Product / Process Change Notification (PCN)

PCN #: PCN_FeSTAR-CLIP_20231006

Affected Series: WE-STAR-CLIP; 7427711; 7427713

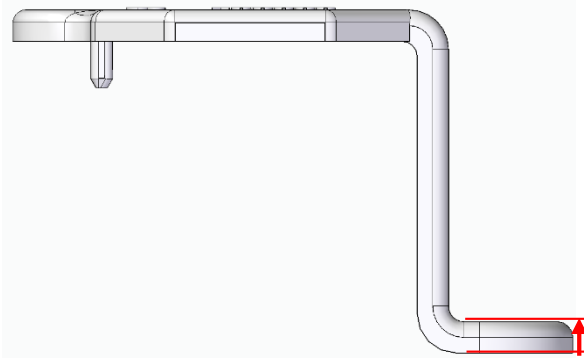
To ensure an improved product assembly, Würth Elektronik will improve the design of the screw fixation area.

Valid for 7427713

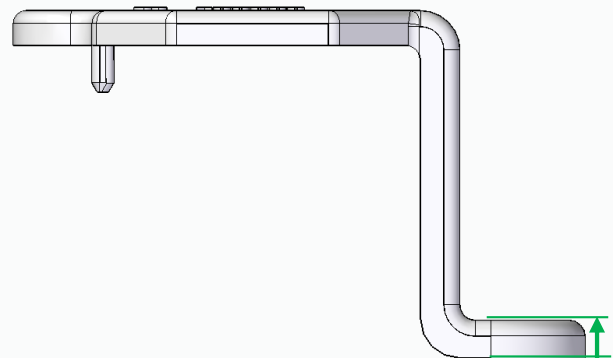
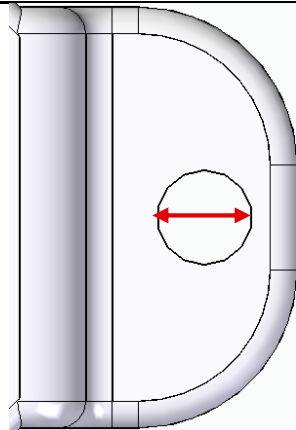
Thickness of the screw fixation area was **2.20 mm**

Thickness of the screw fixation area will be **2.40 mm**

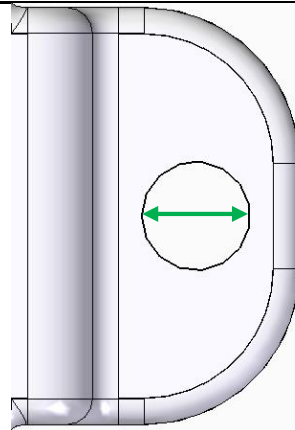
Borehole diameter was **3.60 mm**

Borehole diameter will be **4.20 mm**

Valid for 7427711

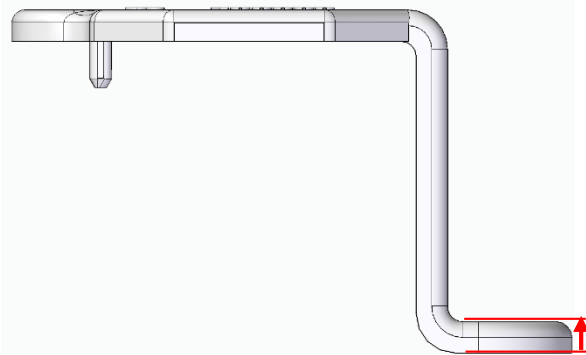
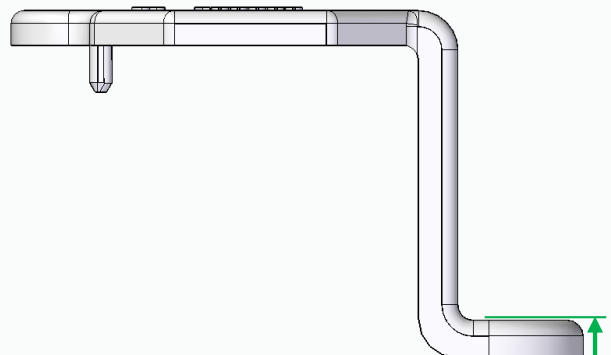
Thickness of the screw fixation area was **2.20 mm**

Thickness of the screw fixation area will be **2.40 mm**.

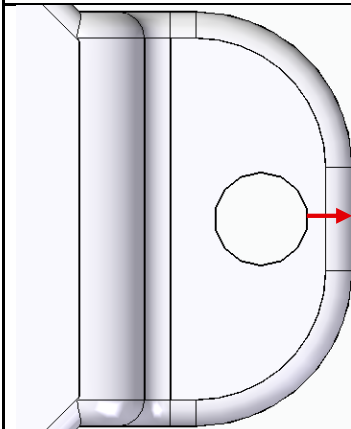
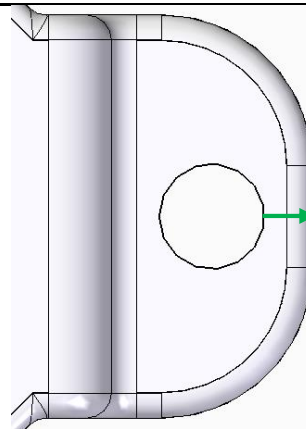
Distance between borehole and edge was **1.50 mm**

Distance between borehole and edge will be **1.90 mm**
